RAPID CITY REGIONAL AIRPORT**ADDENDUM NO. 3**

**Request for Proposals – Integrated Terminal Technology Package
Comprising CUPPS, CUSS, MUFIDS (Including GIDS and BIDS), and Digital Backwall Video Signage
Rapid City Regional Airport**

Date of Issuance: August 12, 2026

**RAPID CITY REGIONAL AIRPORT
RENOVATION AND EXPANSION PROJECT
PROJECT 1 PHASE 3**
Rapid City, South Dakota

1 TYPICAL GATE COUNTER ENLARGED PLAN
1/2" = 1'-0"

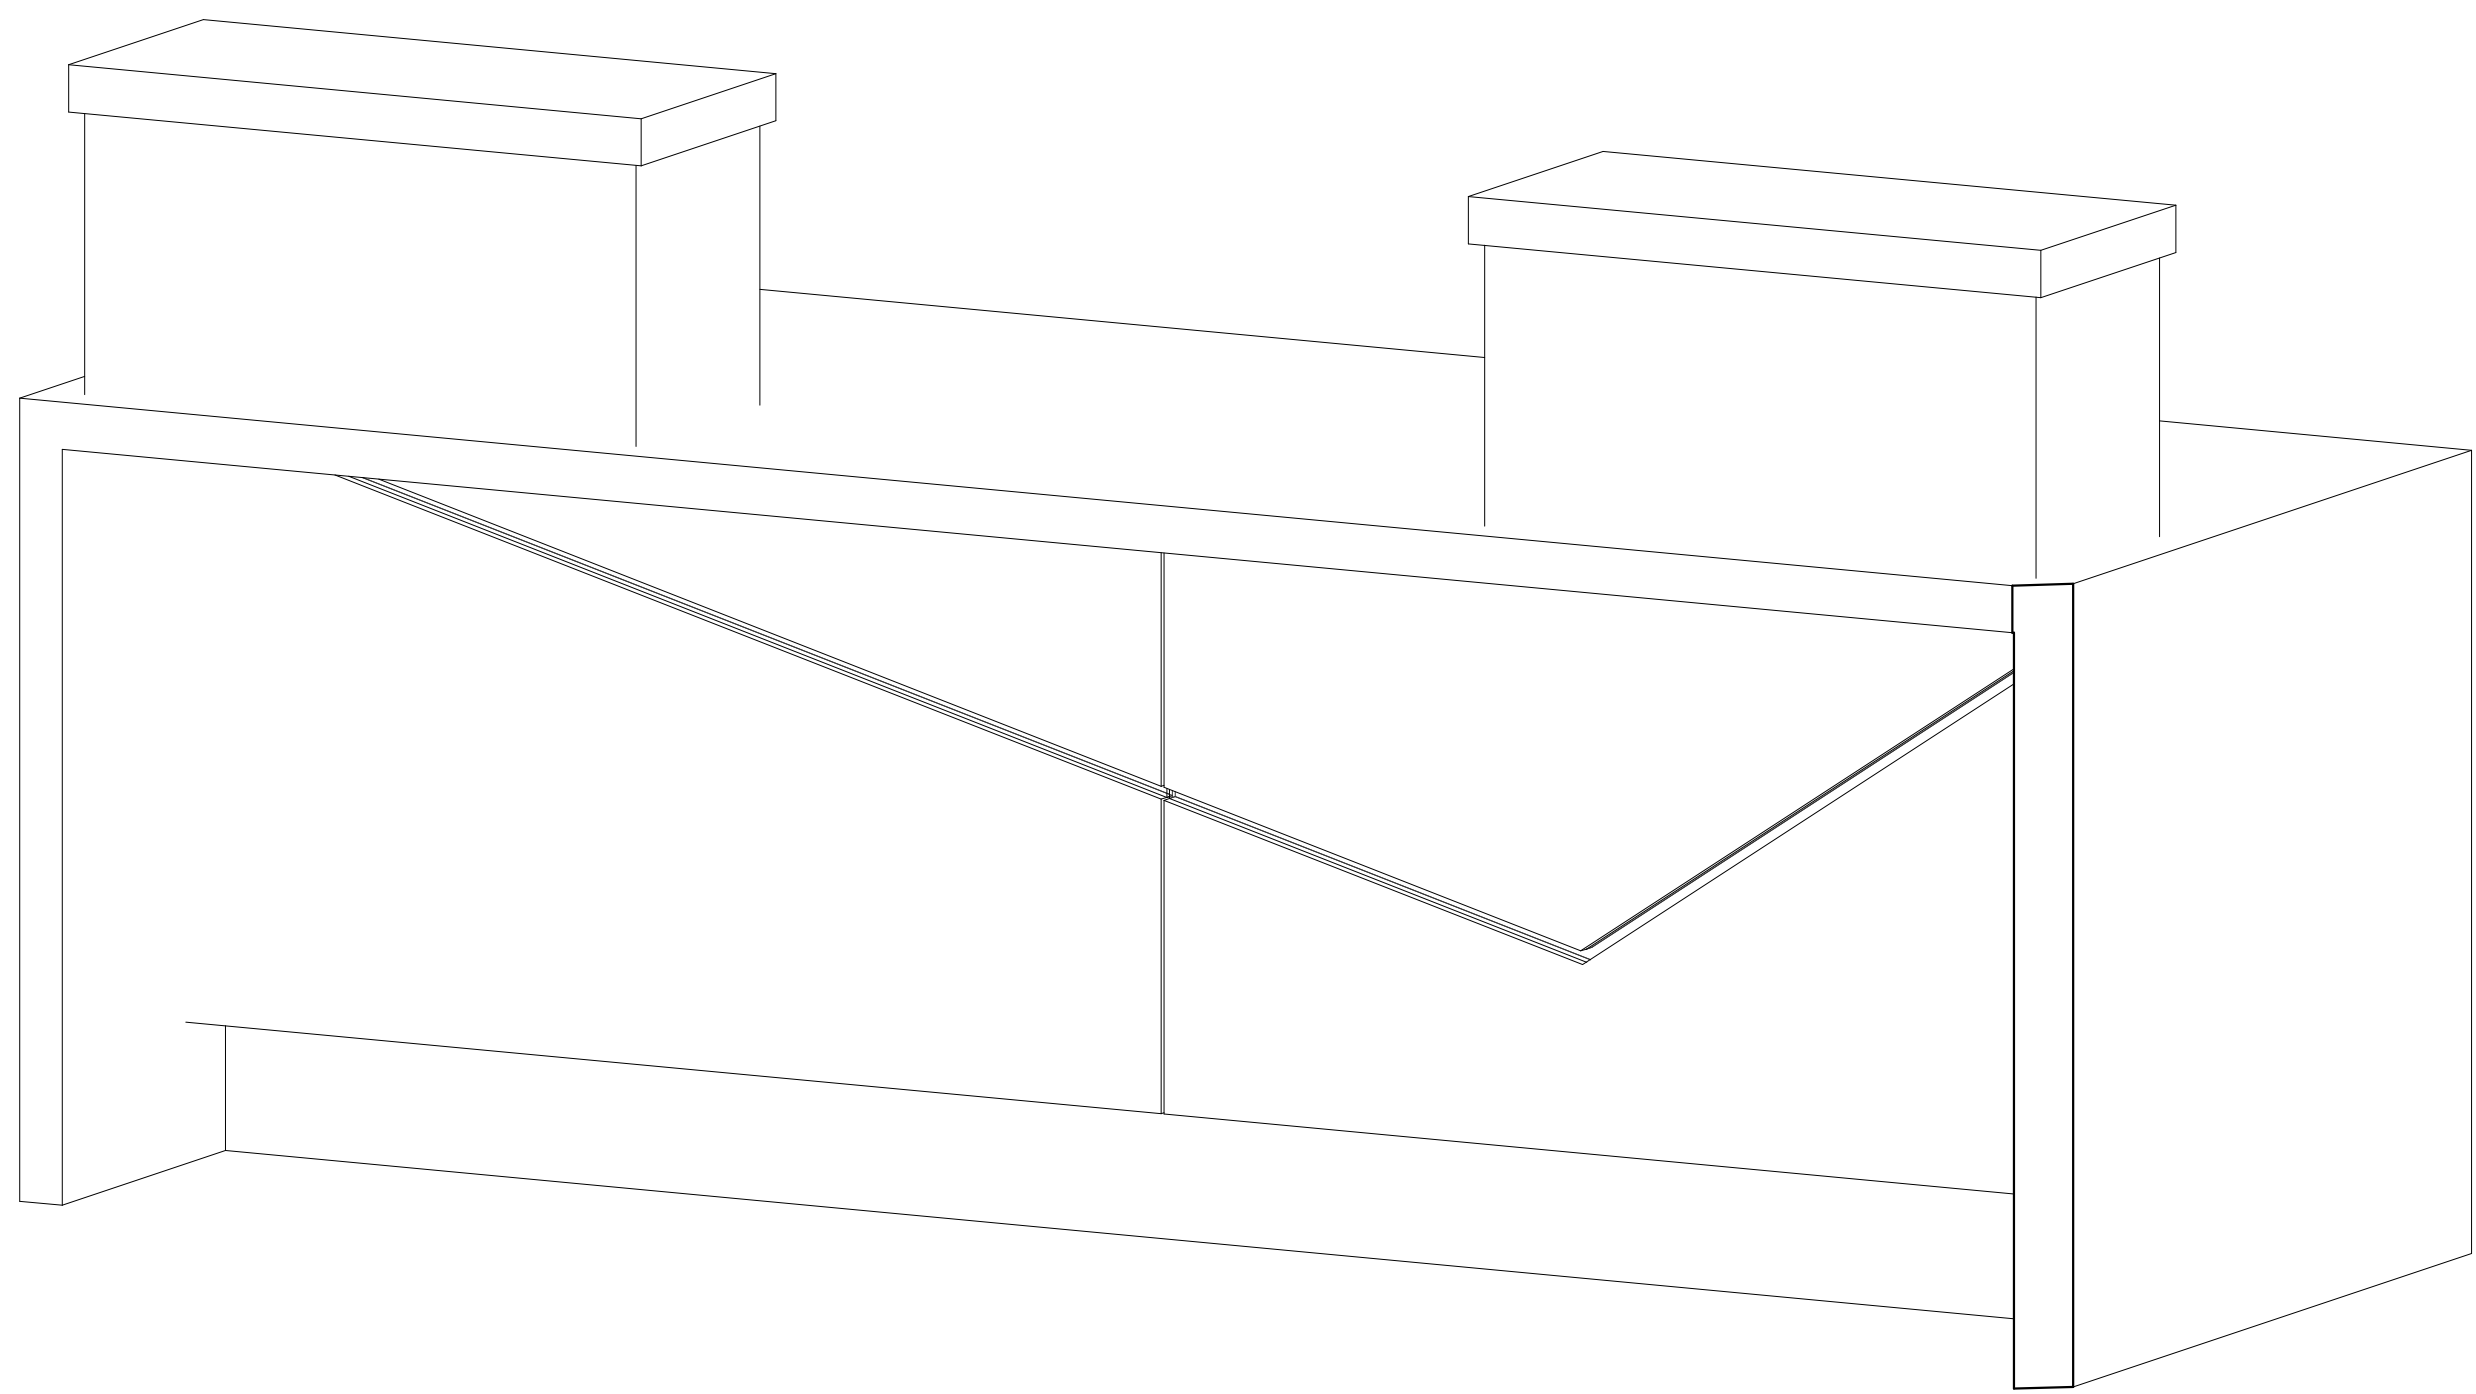
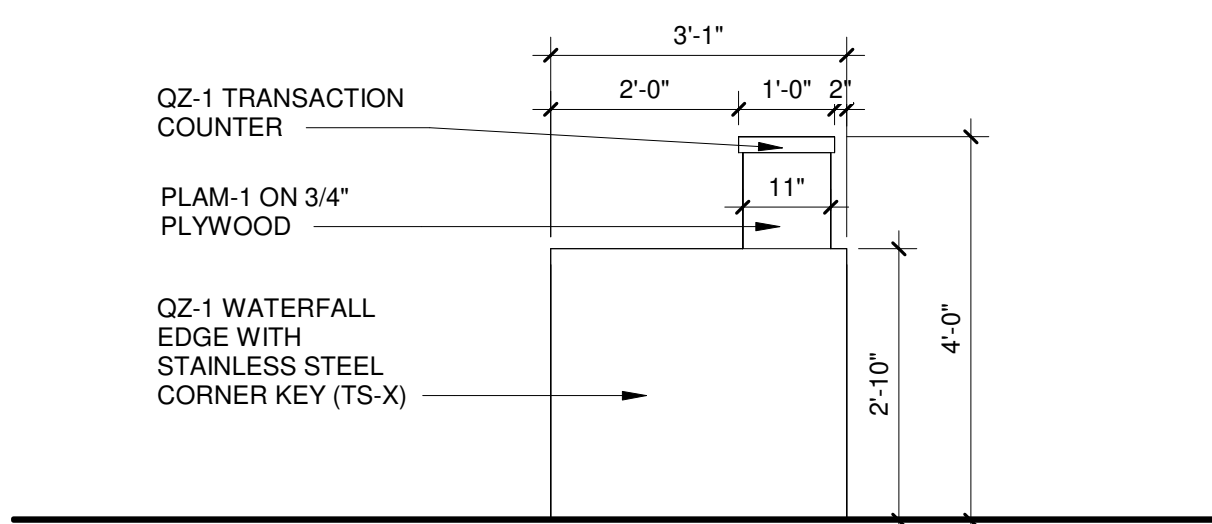
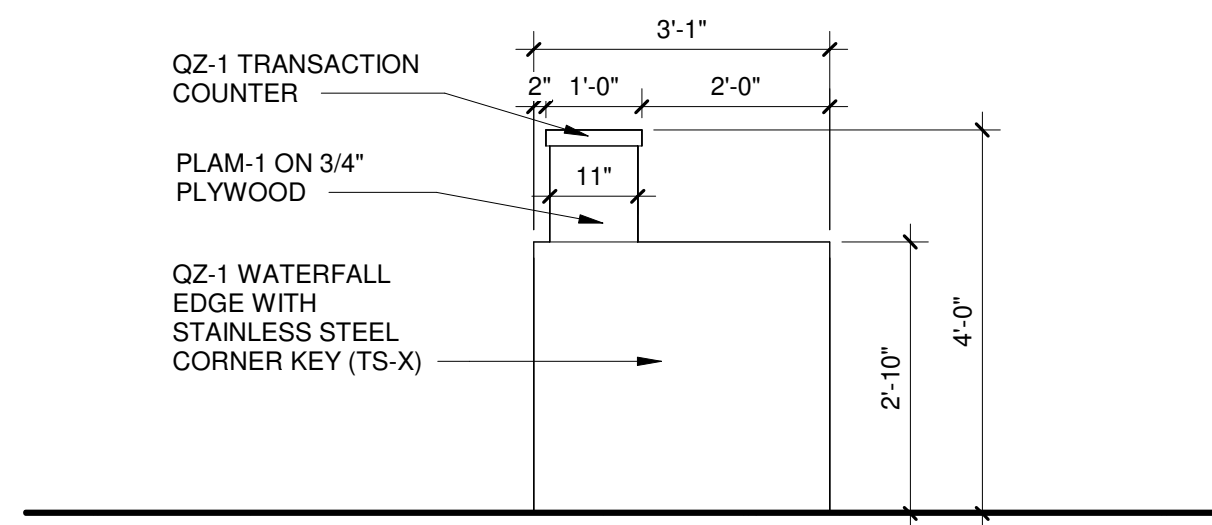
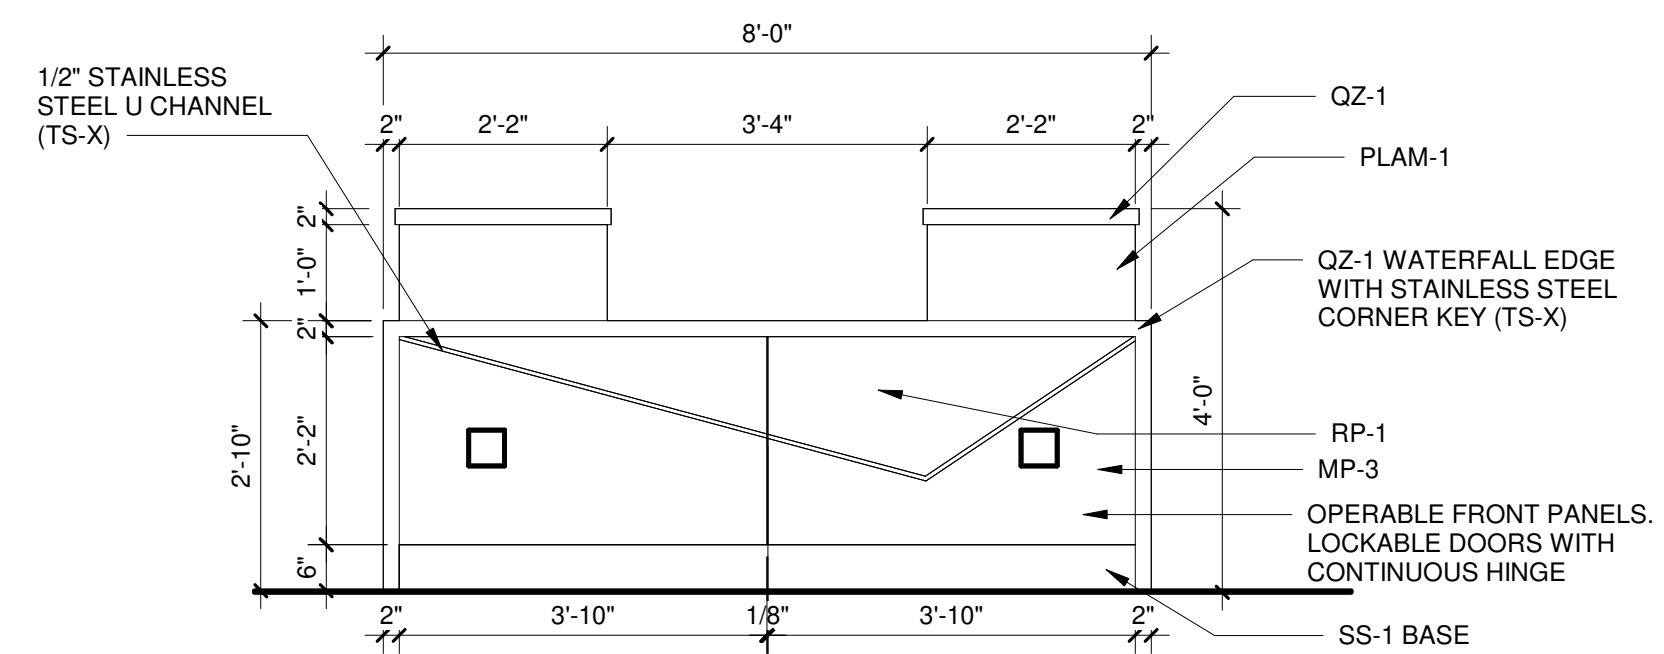
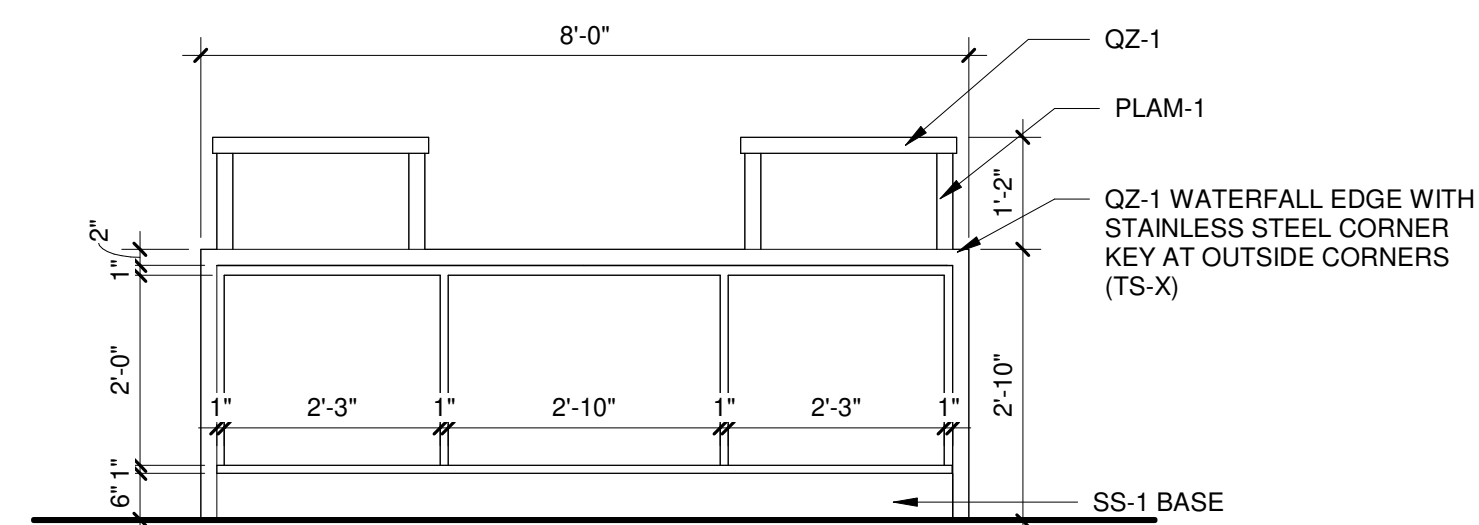
- Attachment 5 – Sheet I-404, Enlarged Ticketing Plans, Elevations, and Details. Each ticket counter module is 8'-0" wide and accommodates two agent positions, consistent with the nine-counter, two-station configuration priced under Section 5.2.1. The baggage scale is Airport-owned and Contractor-installed, with the scale reader integrated into the countertop; it is not a separate CUPPS/CUSS-furnished peripheral. Each position includes a cutout reserved for airline-provided equipment inserts, separate from the Common Use workstation footprint.
- Attachment 6 – Sheet I-407, Enlarged Gate Counter Plans, Elevations, and Details. Each gate counter module is 8'-0" wide and similarly accommodates two agent positions.

Proposers shall size Common Use workstation hardware, peripherals, and cabling to fit within the counter and gate module envelopes shown on Attachments 5 and 6.

1 TICKETING T103 NORTH
1/4" = 1'-0"

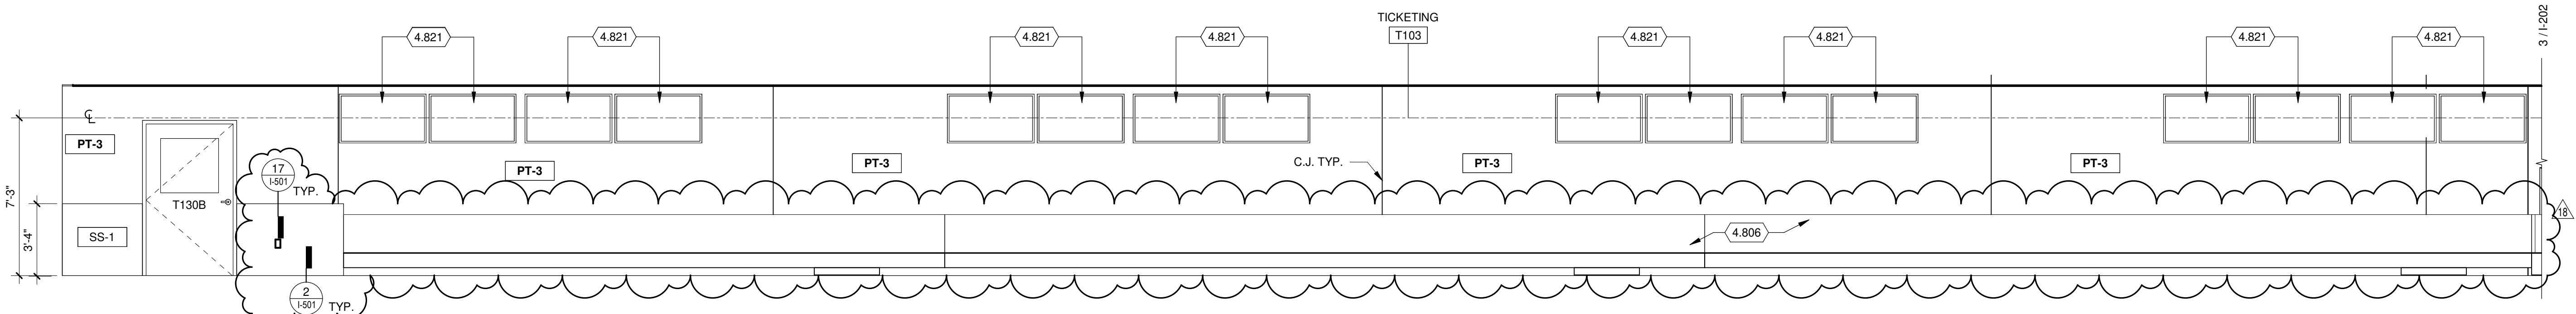
For Proposers bidding the Digital Backwall Video Signage Award Package, the Airport is issuing, as Attachment 7 to this Addendum, Sheet I-202 (Interior Building Elevations – Phase 3), views 1 and 3, showing the Ticketing T103 North and Ticketing T103/Info Center T104 North wall elevations along which the Digital Backwall Video Signage described in Section 5.7 will be installed.

These elevations are issued for Proposers' general spatial reference regarding the wall envelope and column locations along the ticket counter wall. They do not constitute the structural loading criteria, finish tolerances, ambient-light conditions, or calibration/viewing-distance data referenced in Section 5.0 of the Existing System Technical Reference Packet. That information remains outstanding and, to the extent not issued before the Proposal due date, will be coordinated with the awarded Contractor during design consistent with Section 5.7 of the RFP.
